Subject: Duke Energy Carolinas, LLC
Oconee Nuclear Station, Units 1, 2, and 3
Docket Numbers 50-269, 50-270, and 50-287,
Renewed Operating Licenses DPR-38, DPR-47, and DPR-55
Tornado Mitigation License Amendment Request - Response to Request for
Additional Information

Nuclear Regulatory Commission
Tornado Mitigation Licensing Amendment Request - Responses to RAI
June 24, 2010

Enclosure
Responses to RAI

Figure 1

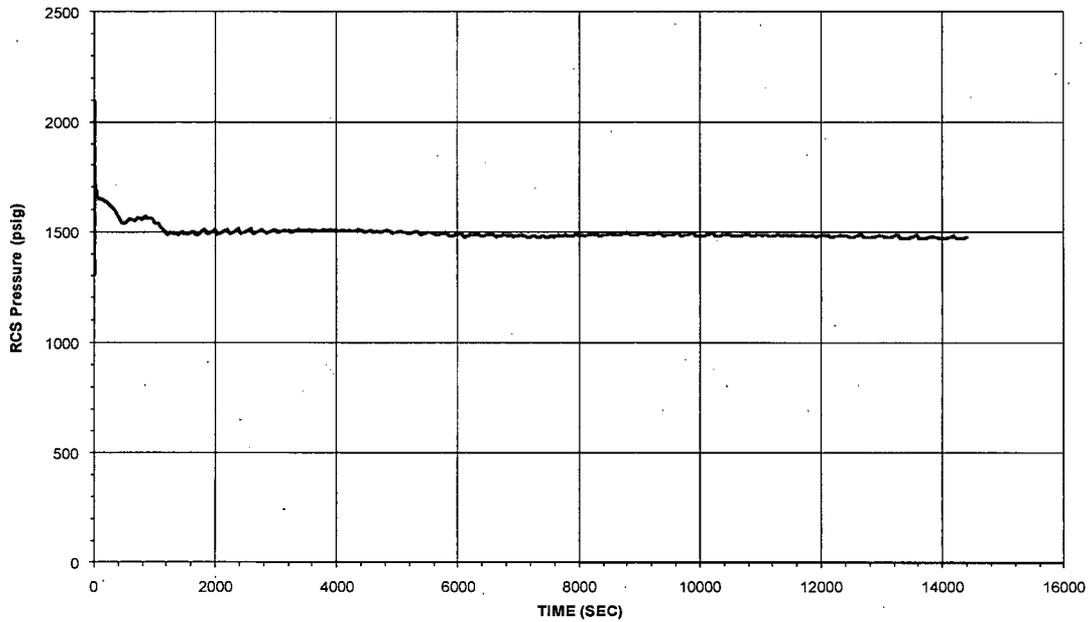
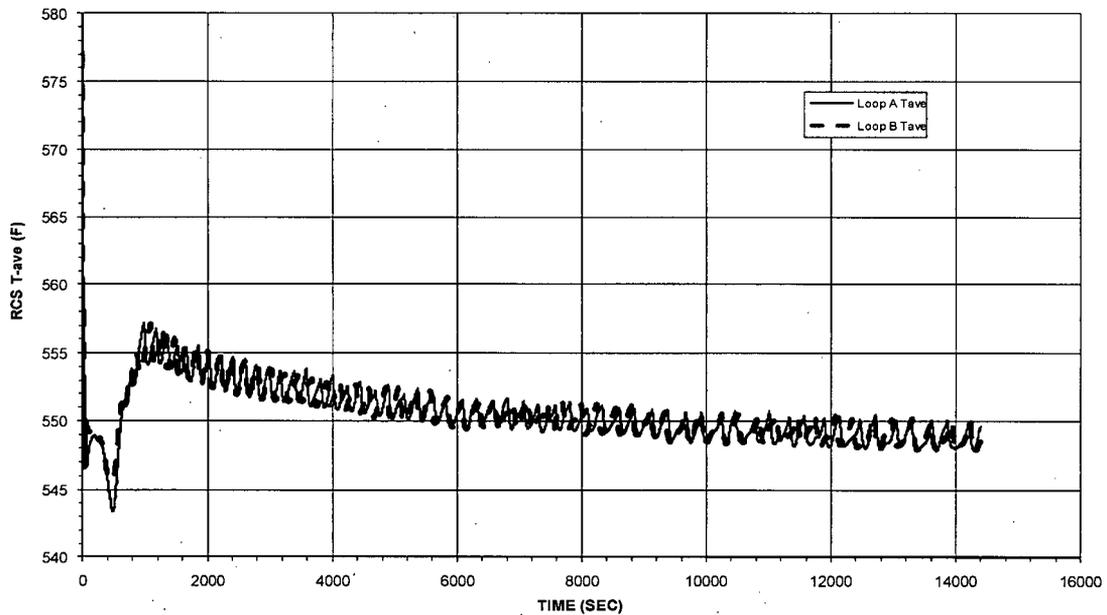
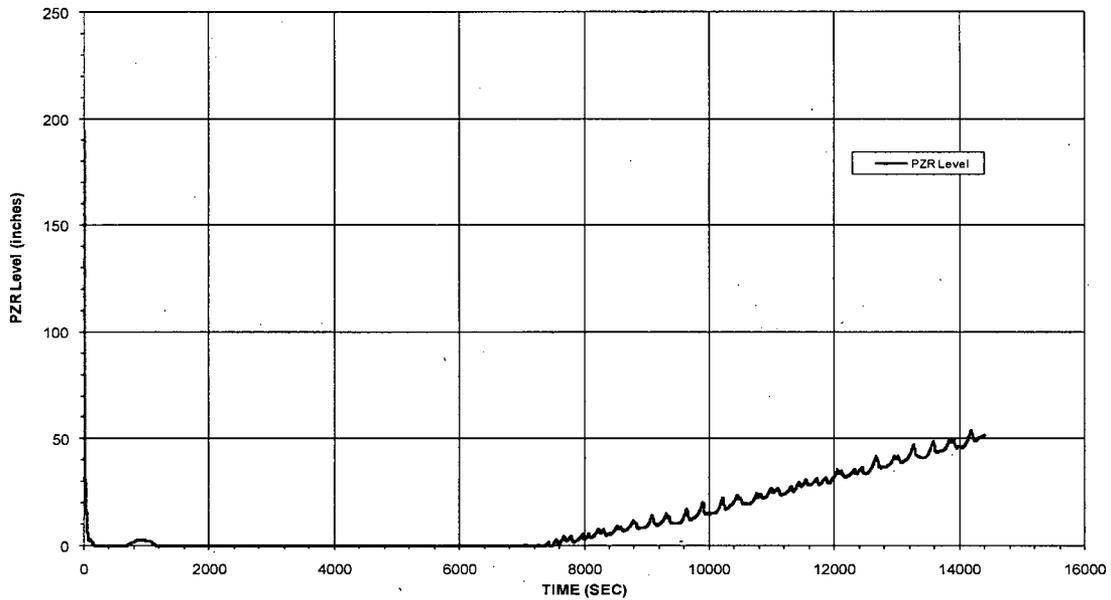
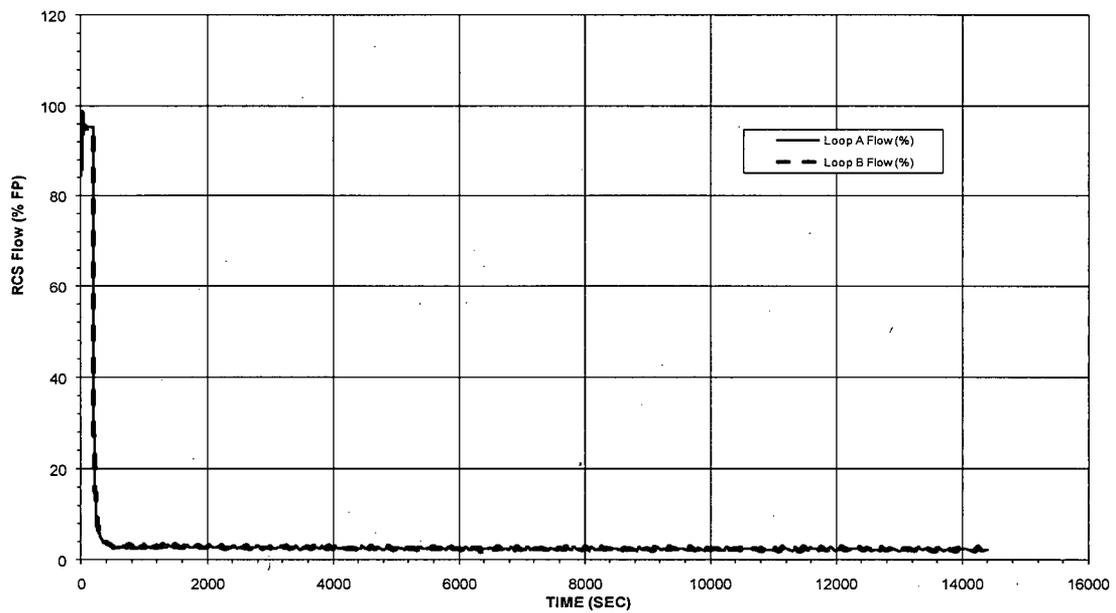
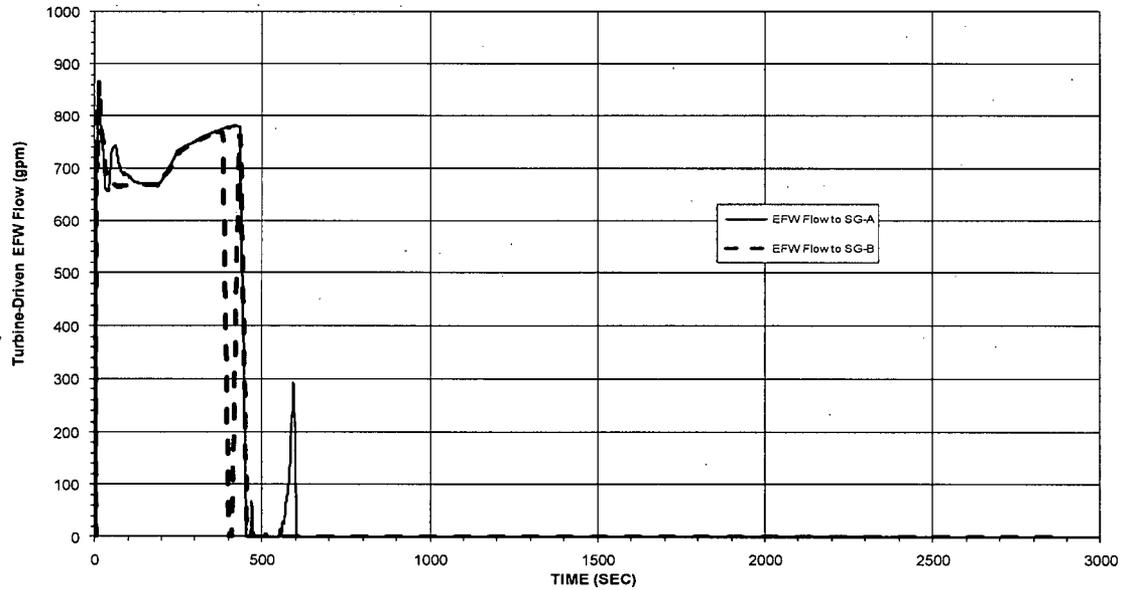
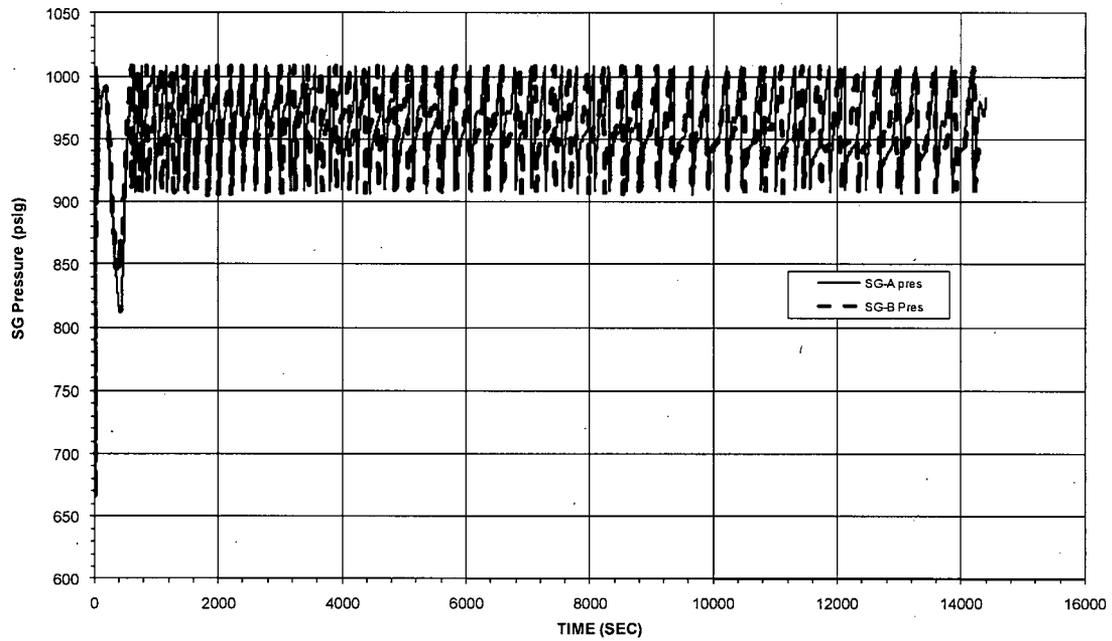
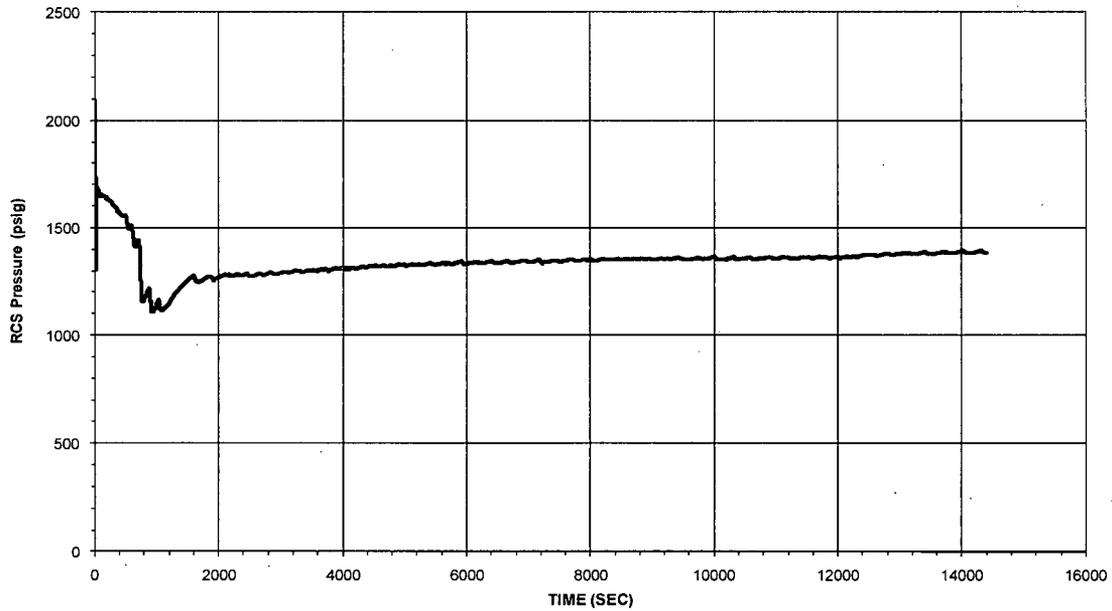
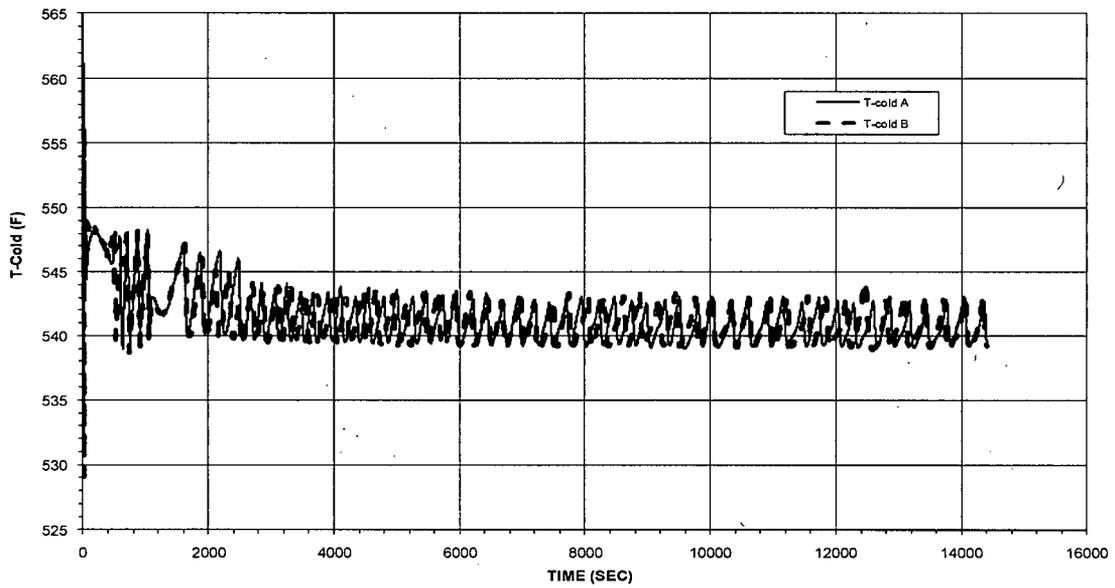
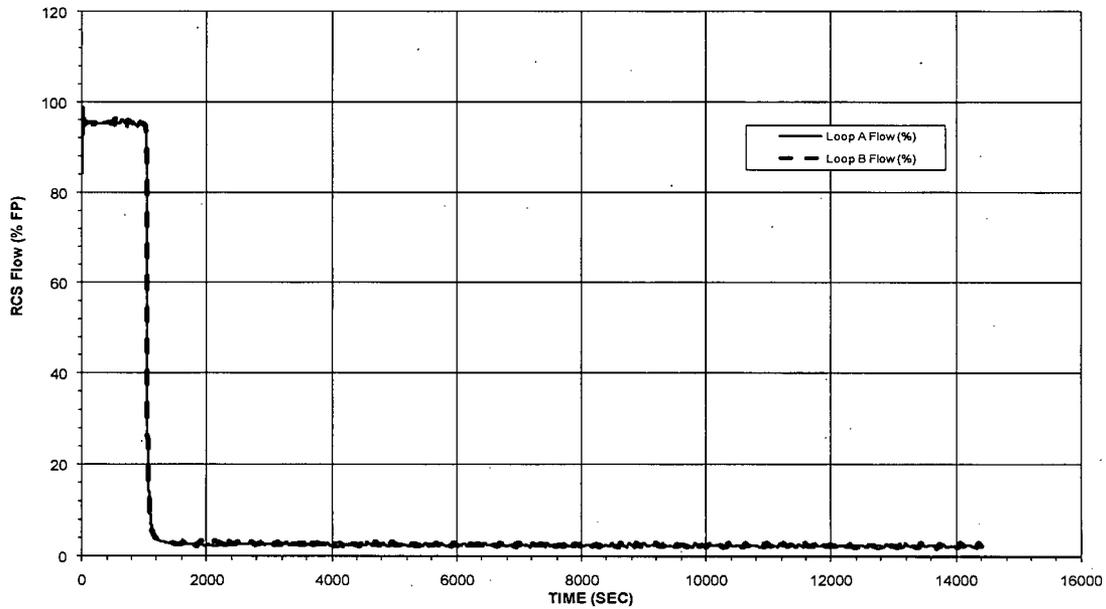
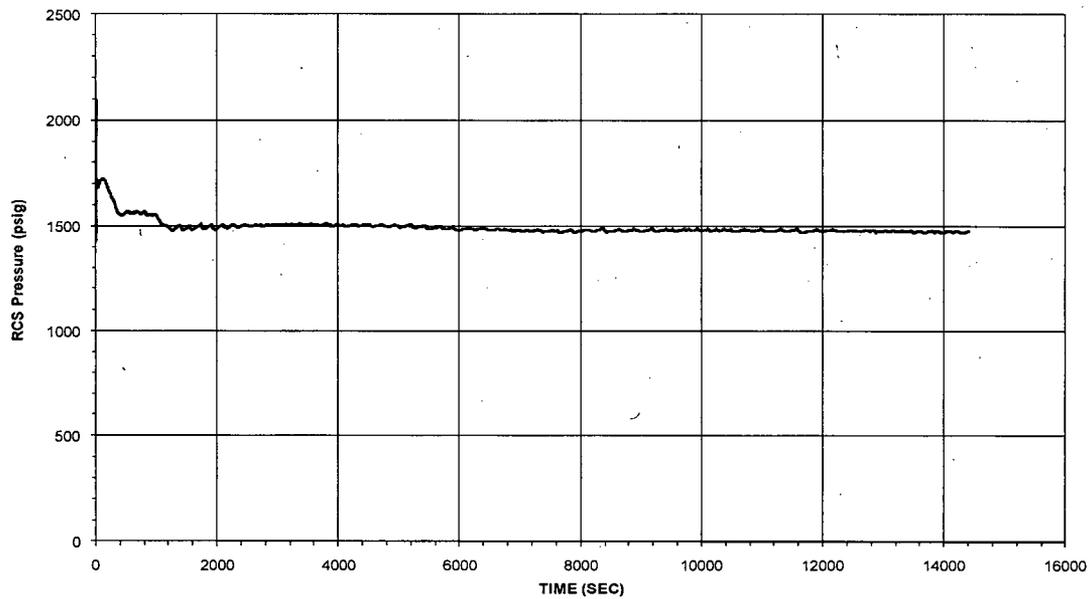
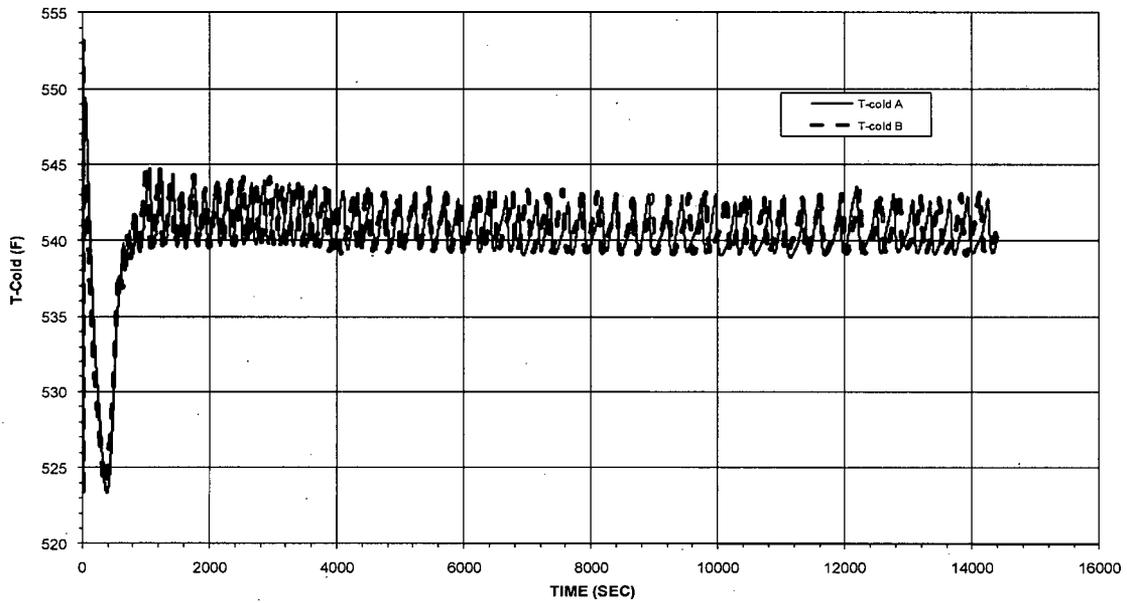
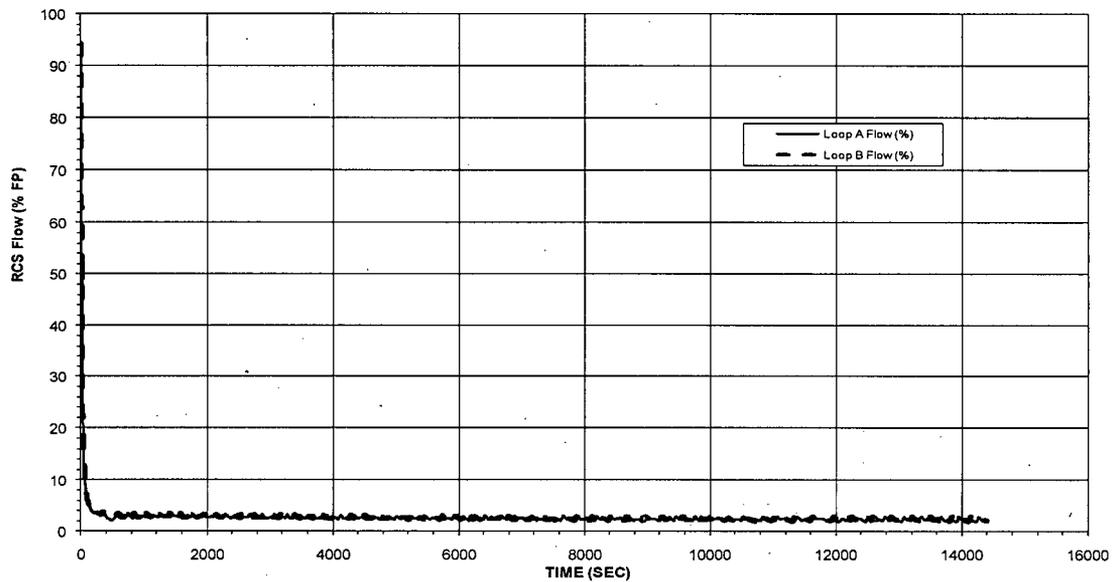
For the worst case main steam line break following a tornado, provide the following information:

- a. Tabulate significant parameters, initial conditions, and results to facilitate comparison among analyzed cases.
- b) Provide plots of significant parameters for the analyzed cases.

The analyses demonstrate that for a double steam line break inside the Turbine Building, coincident with a loss of the 4kV Essential Auxiliary Power System, the SSF can maintain the plant in Mode 3, with $T_{ave} \geq 525^{\circ} \text{ F}$ without interruption of single-phase

Initial Conditions	Target Value	Comment
Core Power (% of 2568 MWt)	102.0	2% uncertainty
RCS pressure (psig)	2095.0	Low value, conservative for RCS depressurization
RCS Tave (°F)	577.0	Low value, maximize overcooling
PZR level (in)	195.0	Low value, maximize overcooling
RCS flow (gpm)	371,360	105.5% Design Flow; not significant parameter due to early RCP trip
Fuel Tave (°F)	950.0	Low value, maximize overcooling
SG Level (%OR)	93%	High value, maximize overcooling
RCP Operation	Varies	See above description
ECCS (HPI)	Unavailable	Loss of 4kV
ECCS (LPI)	Not modeled	
BWST Boron Concentration	N/A	HPI not credited
Main Feedwater	Trip at start of event	MFW pumps coastdown following trip on loss of suction pressure
Emergency Feedwater	Only TDEFW	EFW flow to both SGs, levels controlled to natural circulation setpoint after RCP trip
SSF Auxiliary Service Water	350 gpm/unit (175 gpm/SG)	SSF-ASW initiated 14 minutes after reactor trip, powered by SSF
